City of Langley

Re: File #SPR-23-001; Assessor's Parcel No's: S7345-00-02020-0, S7345-00-02019-0

The City of Langley Planning received your application on January 3, 2023 for the proposed Type I Site Plan Review and variance request to construct 14 dwelling units in a three-building affordable housing development under the multifamily infill provisions of LMC 18.13. During the review process, the City of Langley has identified the following additional information that is needed in order to complete review of your permit:

C2.0

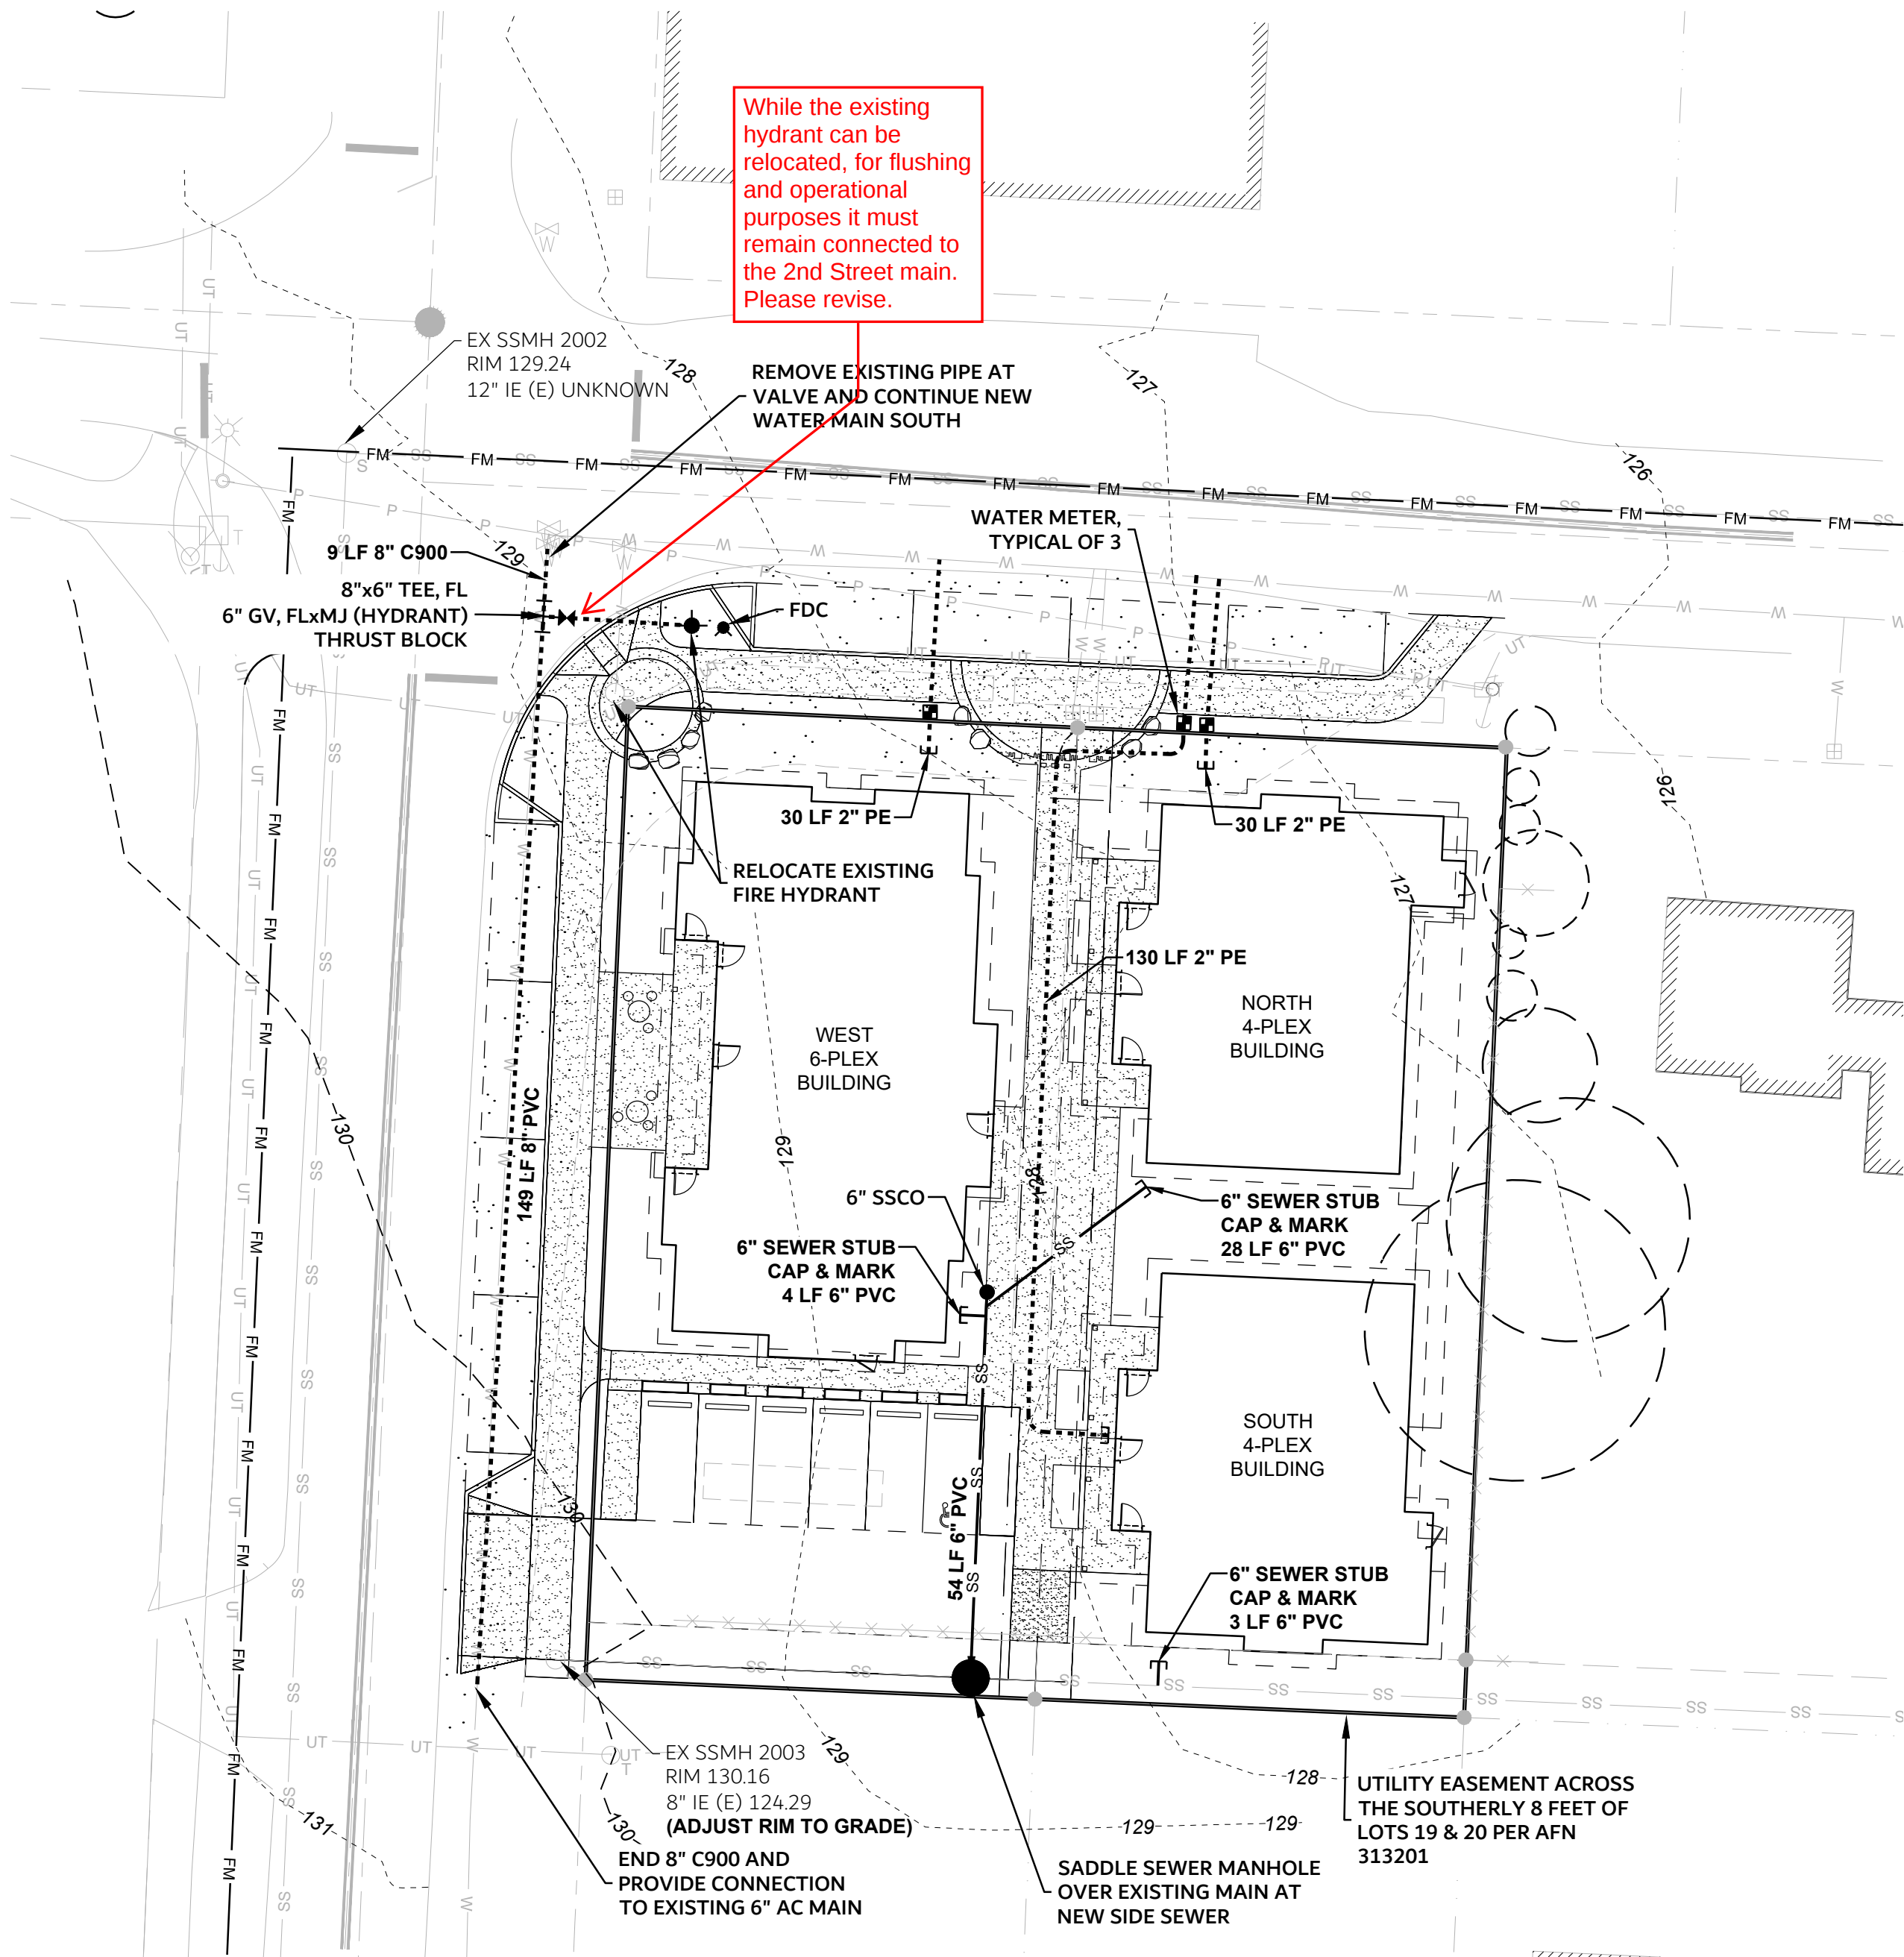
Inspection port/risers are required for the infiltration trenches. Please show in detail and in plan view to ensure feasibility with current layout.

PRELIMINARY
SEWER & WATER PLAN

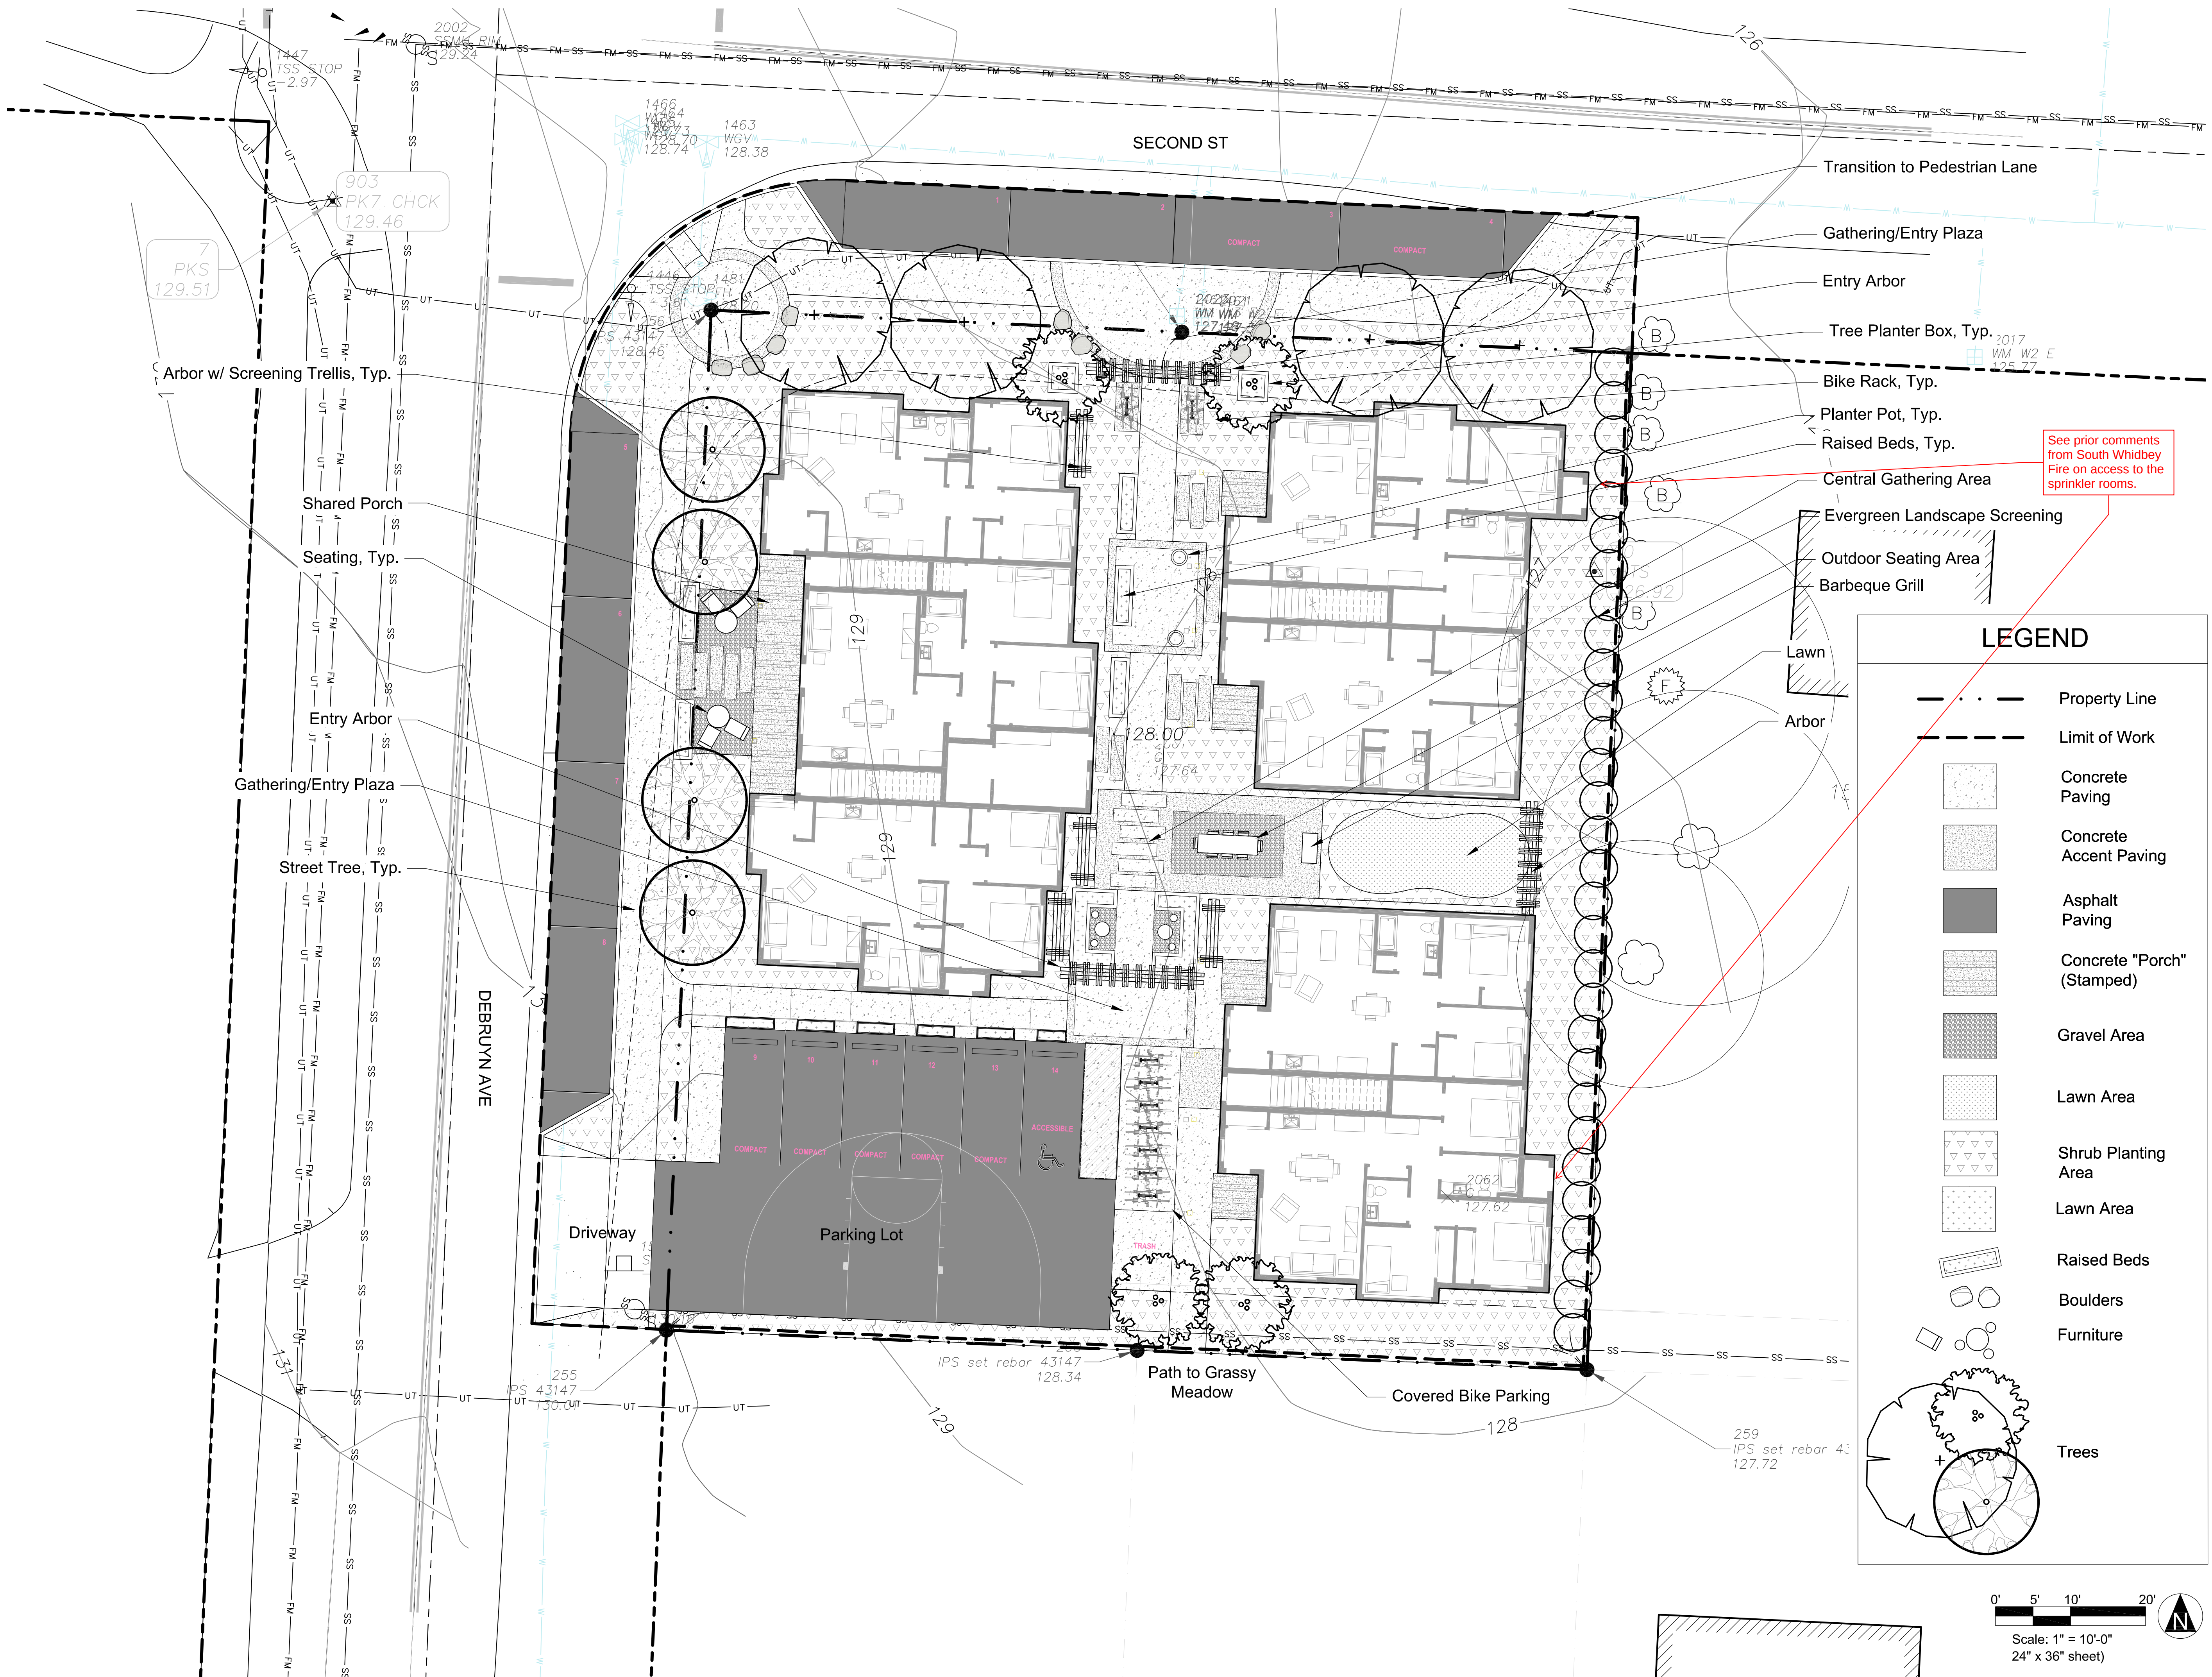
The City prefers individual sub-meters at the main for each individual unit. However per LMC 13.01.100.D single service lines may be allowed to a multi-unit structure or multiple structures provided that one owner has agreed in writing to assume and be responsible for and pay the total water bill without any deductions for vacancies or other reasons. This agreement must be in place prior to approval of the construction drawings.
